## Determination 2012/014

### The code compliance of a deck incorporating a floating in-situ concrete slab over a waterproofing membrane at 38 View Road, Waiheke Island

Figure 1: Section through deck as originally consented

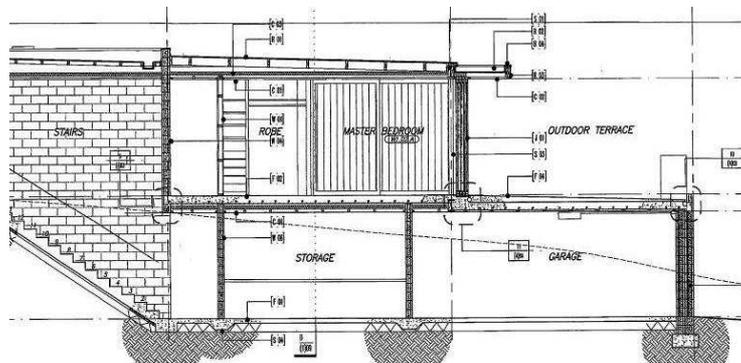
- 2.4 The amended work to the deck comprises the following:
- an in situ concrete slab, minimum 65mm thick, reinforced with galvanised steel mesh and perimeter bars, poured on two layers of polythene, over

- permanent formwork consisting of either 4mm stainless steel sheet, or 15mm H3.2 CCA plywood to maintain the minimum slab thickness, over
  - pedestal support chairs at 300mm centres each way, over

- a two layer torch-on membrane (consisting of 2x3mm layers), with additional 150mm wide membrane strips located under each pedestal, over the existing floor slab.
- 2.5 The deck slopes away from the first floor walls to a perimeter edge drain. A stainless steel channel drain and grate is to be installed where the deck abuts the first floor walls. The membrane has a current BRANZ<sup>4</sup> appraisal certificate. The membrane manufacturer has offered a 20-year product warranty for the use of the membrane in this location.

- outline how the membrane below the proposed concrete slab can be inspected and maintained to meet the durability requirements of the building code.
- 3.6 The parties could not agree on the extent of maintenance required and the Department subsequently received an application for a determination on 21 November 2011.

- 5.3.1 The authority is of the view that access must be provided to the membrane so that it can be maintained and that the access is required to maintain the membrane in order for it to comply with Clause B2.

- 5.3.5 In this instance the membrane is protected by the topping slab, which will prevent any UV degradation and mechanical or traffic damage. In this situation it is reasonable to take the view that the membrane will not, in the normal course of events, require regular maintenance.
- 5.3.6 I also note that the authority's practice note (refer paragraph 5.1.2) provides for the acceptance direct fixing of tiles to membranes where the membrane is applied to concrete. The ability to maintain membranes in those circumstances is similar to that discussed here.

- 6.1 In accordance with section 188 of the Building Act 2004, I hereby determine that the amended work to the deck, as described in paragraph 1.5 of this determination, complies with Clauses E2 External Moisture and B2 Durability of the Building Code.
